December 22, 2023

Stacie McIntosh
Bureau of Land Management
222 W. 7th Ave., Stop #13
Anchorage, AK 99513
s05mcint@blm.gov

Re: Comments for the Supplemental Draft Environmental Impact Statement for the Proposed Ambler Mining District Industrial Access Road

¹²³⁸ 4 SEIS at Map 3-25.

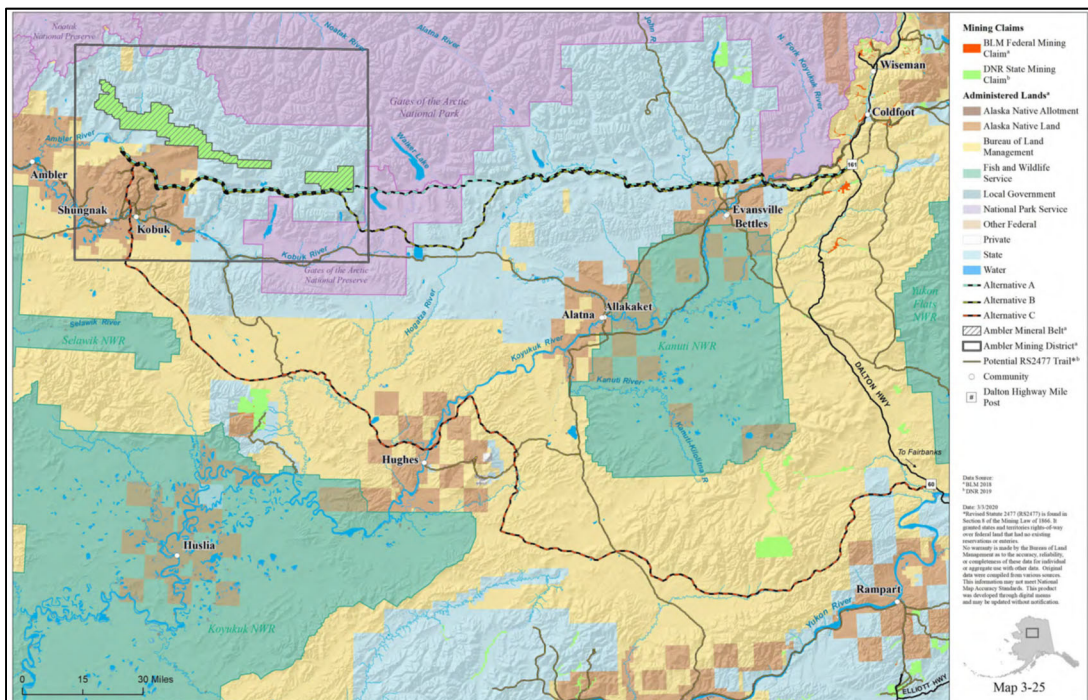
In stark contrast, BLM’s mining claims map in the draft SEIS highlights mining claims in the region in light green, but the entire collection of mining claims along the eastern half of the road corridor is missing:¹²³⁸
